This submitted the surveyor he requested  
to inform the owners that the rule  
requirements for the hatchway web  
is a plate  $23\frac{1}{2}'' \times .40$  with double  
angles top and bottom  $5 \times 3\frac{1}{2} \times .50$   
and the web the fitted must be  
equivalent thereto.

### Rule

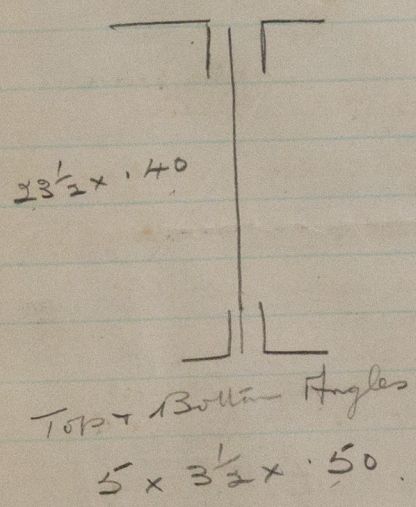
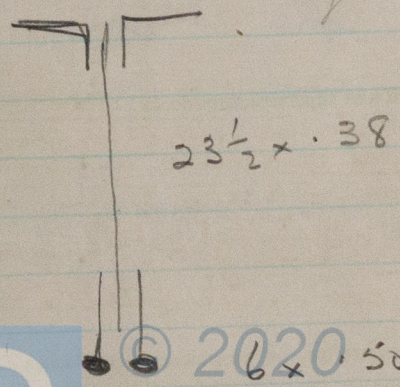
If it be desired to dispense with  
bottom angles the web would  
require the of the scantlings  
intimated in the Secretary's  
letter of 10<sup>th</sup> inst.
